Comments on Replacement of Fire Alarm System and Manual Toll Collection System in the Aberdeen Tunnel, and Traffic and Control Surveillance Systems in the Eastern Harbour Crossing and the Kai Tak Tunnel for Legco's Panel on Transport

by J Kwong 2016 04 13

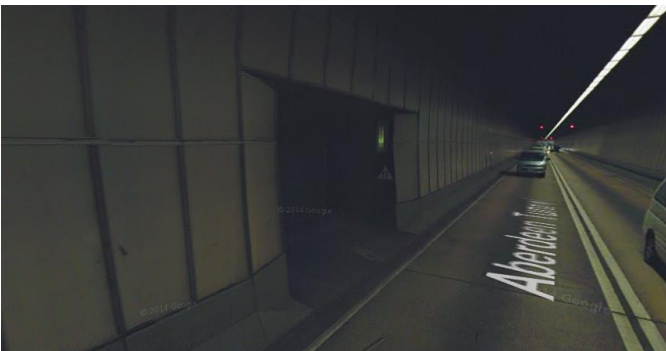
Guidance to "To Kwa Wan" on westbound tunnel tube is too late. Advance direction signs for the exit are missing.
